Engineering revision handoff

Engineering file ID 25.2 | SR1 builds on E1

21.2B SR1 adds mechanical switch retention following version 26's split-cage and removable-clamp principle. The compact 38 mm speaker concept is preserved. Version 26 itself is unchanged and was not requalified.

Walkie One 21.2B | SR1 mechanical switch capture

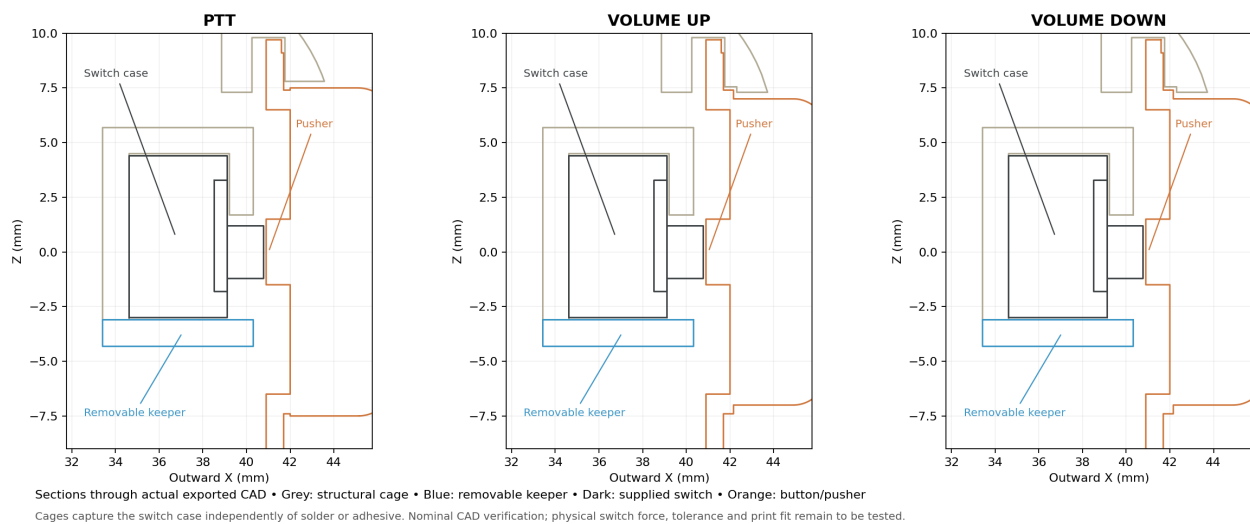
- Added three B3F-3150 cages integrated into the front housing and removable screwed rear keepers.
- Added isolated side pushers, captive shoes, nominal 0.14 mm rest gaps and 0.65 mm stops; relieved rear alignment features for loading.
- Preserved the E1 screwed front-switch reaction plate and the compact enclosure / 38 mm speaker design.

- 24 of 24 switch-body translation probes meet opposed retaining surfaces: four switches, six directions, 0.35 mm displacement.
- 18 side-button positions from 0 to 0.65 mm, 21 rear-loading positions, and six side-keeper screw-head envelopes checked.
- No unwanted static intersections above 0.0001 mm³ in the screened parts/hardware. STEP solids are valid; changed-part meshes are watertight.
